Interactive comment on “Flash flood occurrence and relation to the rainfall hazard in a highly urbanized area” by K. Papagiannaki et al.

ANSWERS TO REFEREE COMMENTS We would like to sincerely thank Martin Mergili and the anonymous referee for the constructive comments that helped us to improve the presentation and the overall argumentation and quality of our paper. Following the reviewers' comments and suggestions we proceeded to a careful revision of the article. In more detail, the following changes have been made in accordance with the respective comments:

Fig. 1. Figure 1. Map of target area and locations of surface meteorological stations. Stations are named by the municipalities they are located in.

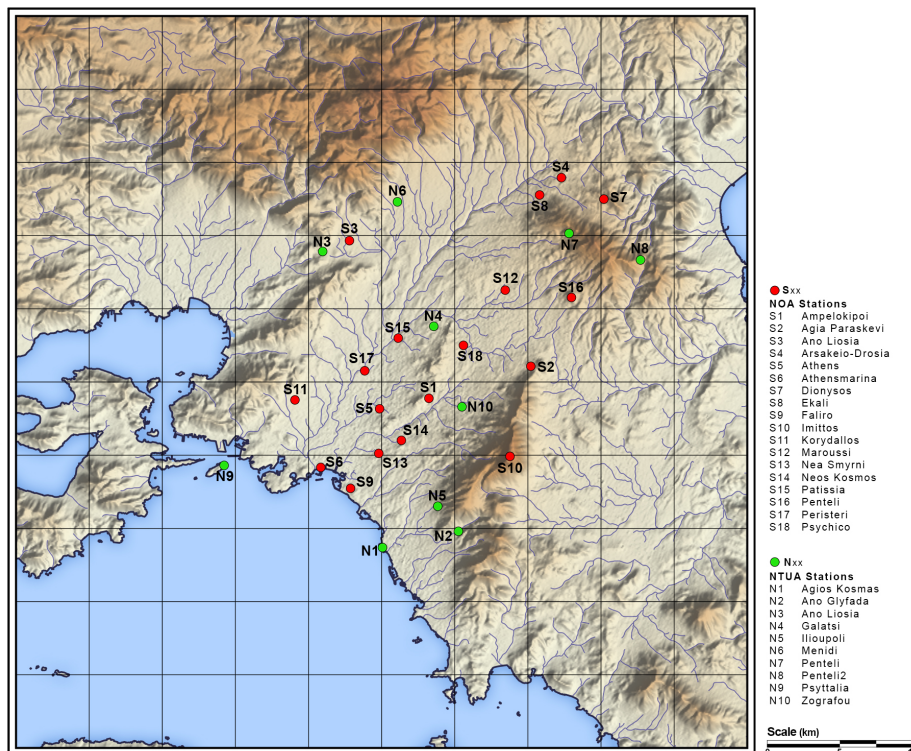
4. 'Figs. 1–3 need a scale bar (alternatively, you may mention the grid spacing)'

5. 'As the article concerns both natural and socio-economic issues, it would be good if you could add the most important towns (if possible, as areal signatures) to Fig. 1. Further, the green and red symbols should be shown also in the legend (even though it is clear what they mean)'

11. 'Figure 1. You could reduce the region presented in the figure and increase the size of the numbers and the corresponding stations. I am afraid it won't be clear for the readers'

Figures have been revised according to the suggestion.

Green and red symbols have been added in the legend as suggested. In what concerns the towns, we believe that a greater size of the picture would be required for a clear printing of the respective names. The legend of Fig.1 lists the meteorological stations, which are named by the municipality in which they are located. Therefore, we added in the caption an explanation about the origin of the stations' names. Main municipalities are also shown in Fig.2, in which, as explained in section 3 'Methodological issues': 'The name of each area derives from the respective municipality that covers the major part of it.'

The size of the number has been increased as suggested.

Fig. 3. Figure 3. a) Number of flash flood events per sub-area.

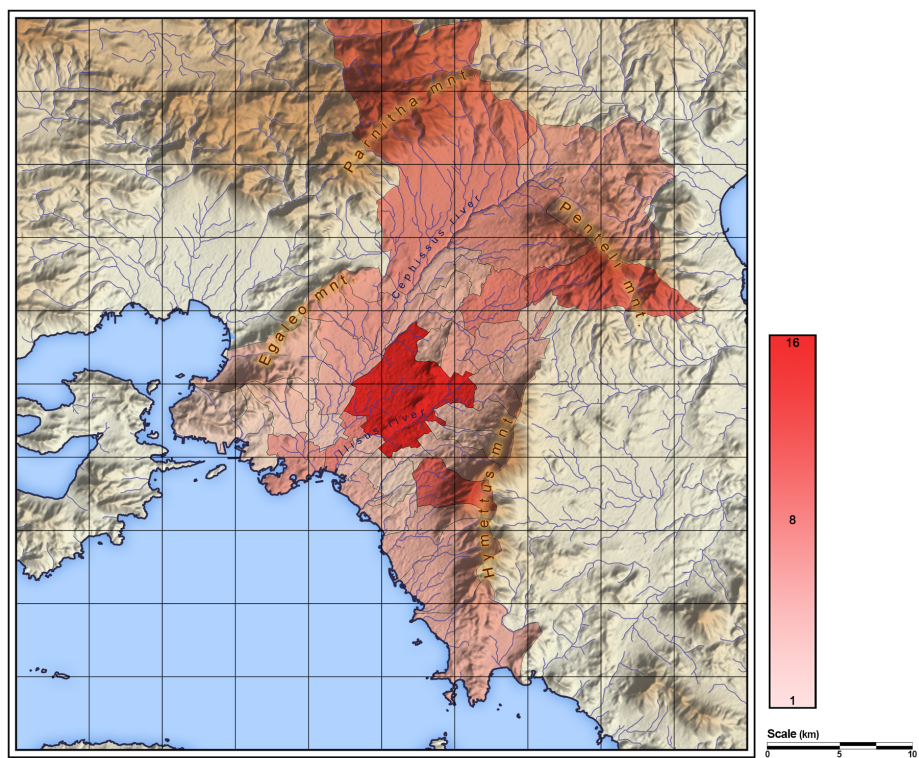
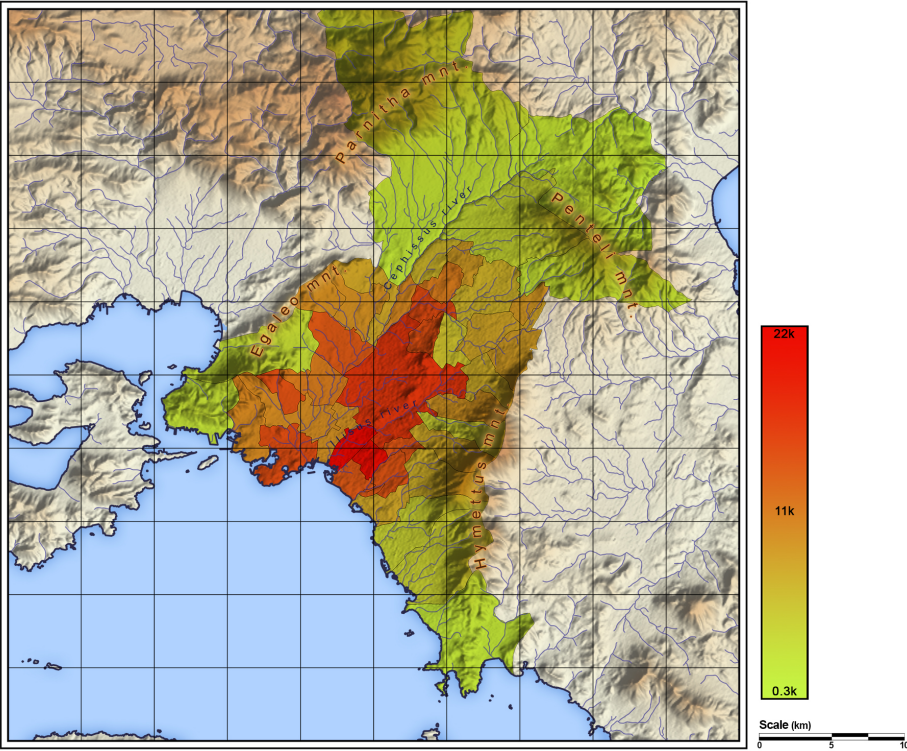
12. 'Figure 3 has not legend explaining the colours meaning.'

The caption of the figure has been revised.

Fig. 6. Figure 4. Quantile distribution plots for b) R10 observations. Fraction of data relates to the number of Fire Service operations.

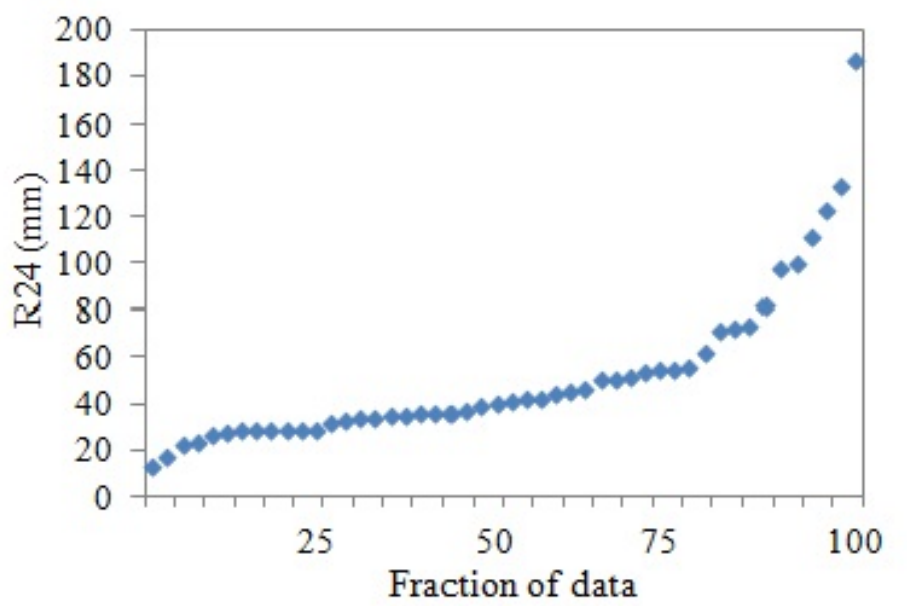
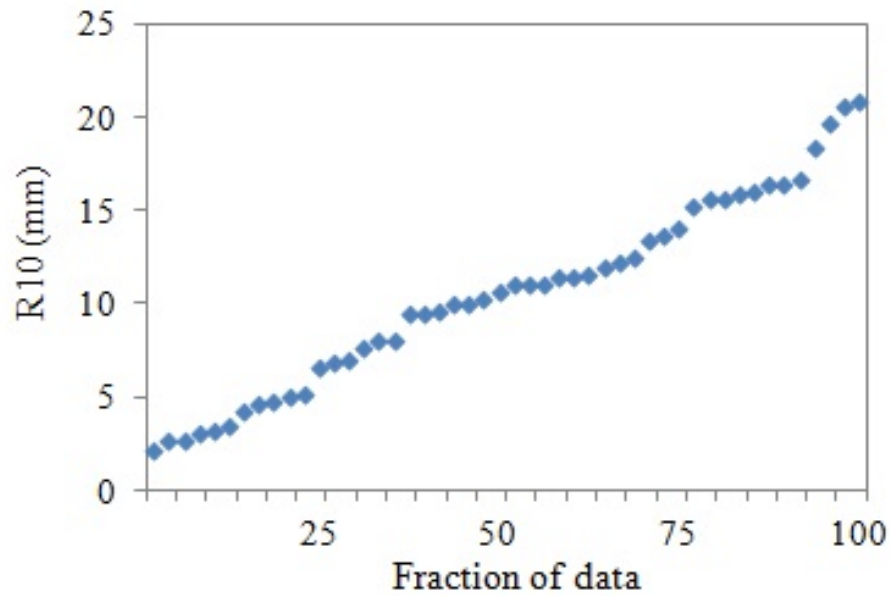
6. 'Fig. 4: I think that the y axis label of the right pane should be replaced by "R10"? In fact, the two figures look very similar, probably the right one has to be replaced by another one at all ... Further, you should write in the caption that the fraction of data relates to the fire brigade reports'

The reviewer correctly observed that the Fig.4b is the wrong one. We replaced it by the correct one. The caption has been also revised according to the suggestion.

Fig. 7. Figure 5. Number of events, Fire Service operations and average number of operations per event for various ranges of (a) 24-h (R24)

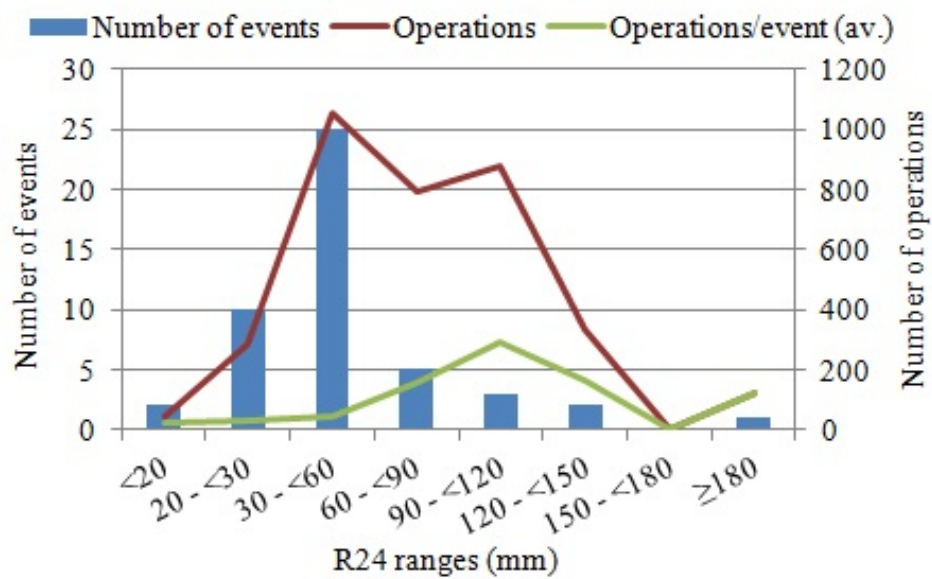
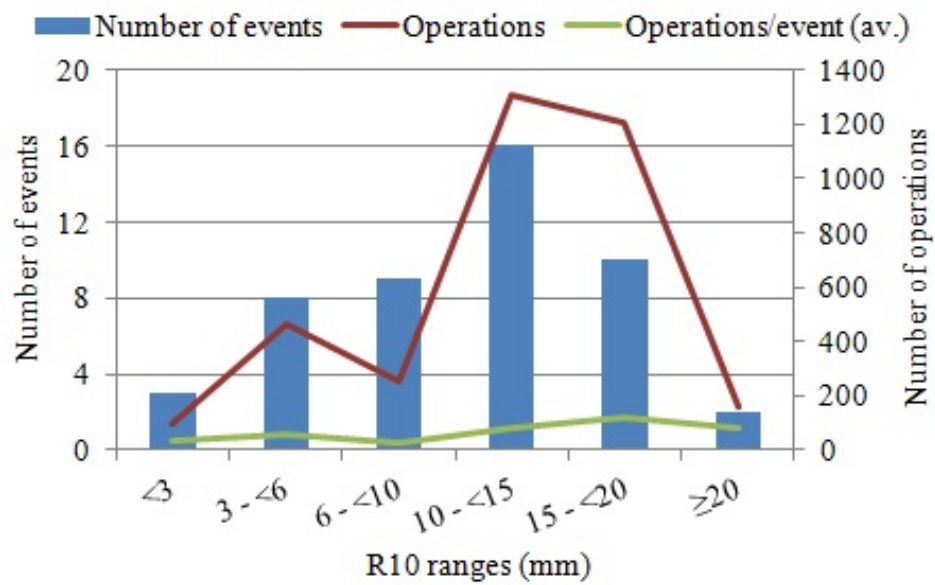
7. 'Fig. 5: Be careful, the x axis tick mark labelling is incorrect. E.g., R24 of 30 mm is actually assigned to two classes, this is not allowed. 30 – <60 mm, 60 – <90 mm etc. would be correct'

8. 'Figs. 5 and 6: It might be good to show a graph relating the number of events and the number of the fire brigade operations (e.g., building a ratio between the two). However, it is the decision of the authors whether they would like to try doing so.'

The figures have been corrected according to the suggestion.

The ratios operation/event for various ranges of 24-h (R24) and 10-min (R10) accumu-

lated rainfall is discussed in the text, section 4.1. Figures 5a,b have been revised to include the respective data, according to the suggestion.
